Control No. PCN-16431

PRODUCT/PROCESS CHANGE NOTIFICATION

TYPE OF CHANGE: ☐ Design ☒ Manufacturing ☐ Other

Figure 1: Current Bonding Diagram

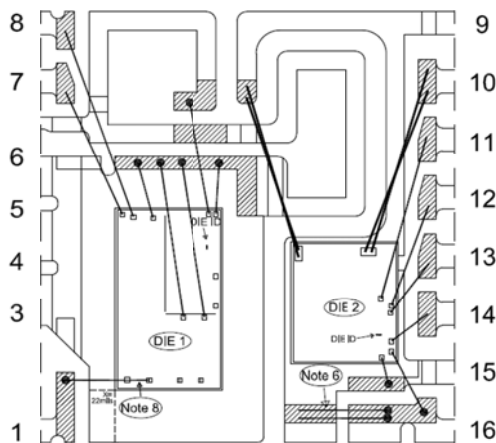
Eliminate a redundant wire each at pins 9 and 10. The current eSOP-R products were introduced with dual wires at pins 9 and 10 for extra mechanical strength during the assembly process. Based on extensive evaluations, it was determined that single wires at pins 9 and 10, as shown in Figure 2, are adequate to achieve the same mechanical strength.
